OVER THE CAMDEN, N. J. MAY 14, 1937. SOLDERING IRON

PREPARED FOR THE INFORMATION AND USE OF RCA VICTOR DISTRIBUTORS' SERVICE MANAGERS

STOCK #151 & 151A
OSCILLOGRAPH

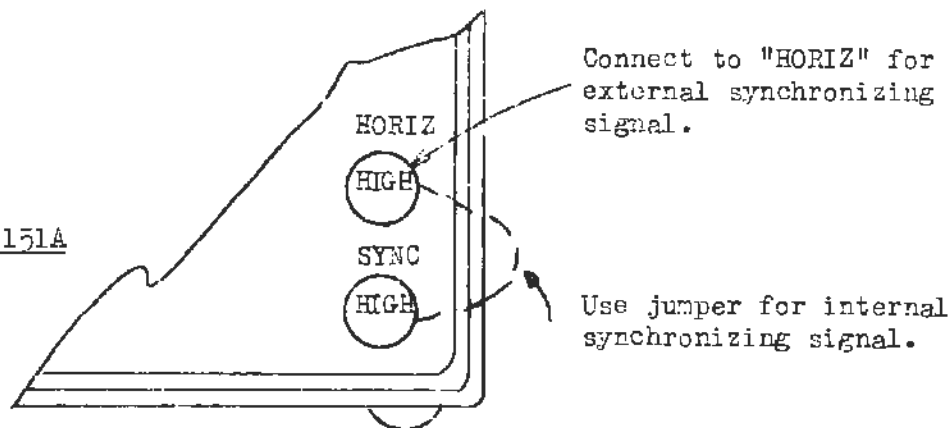
Unless proper connections are made at the "HORIZ-SYNC" terminals, it will be impossible to lock-in the synchronizing signal or to control it correctly. The terminal marked "HORIZ" is the input to the horizontal amplifier and the "SYNC" terminal is used for connection

purposes only in order to employ internal synchronization. When external synchronization is to be used, attach the source of the signal to "HORIZ" and "O" terminals of the oscillograph, and turn the Amp.-H switch to "Timing". For internal synchronization, a jumper lead such as shown above, should be connected between "HORIZ" and "SYNC", and the Amp.-H switch placed in the "Timing" position.

VOLUME CONTROL REPAIR

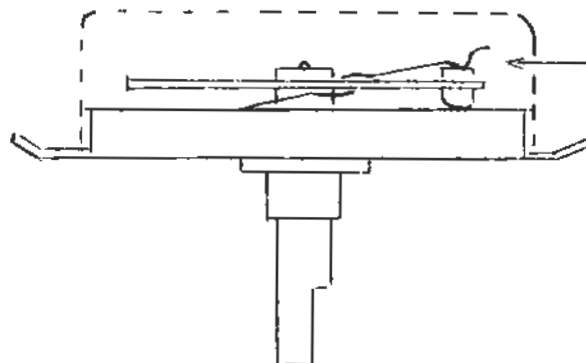
Many controls of the Stock #11237, #11205 and #5223 types have a construction as shown by the sketch below. Any noise developing on these units can be satisfactorily eliminated by cleaning the contact

Contact point between spring and shoe must be cleaned.

point between the phosphor bronze spring of the wiper arm and the monel metal sliding shoe. The cleaning should be done by drawing a strip of crocus cloth or very fine sandpaper through the contact so as to clean both parts. A small amount of very light oil or Vaseline applied to the contact surfaces after cleaning will prevent future corrosion.
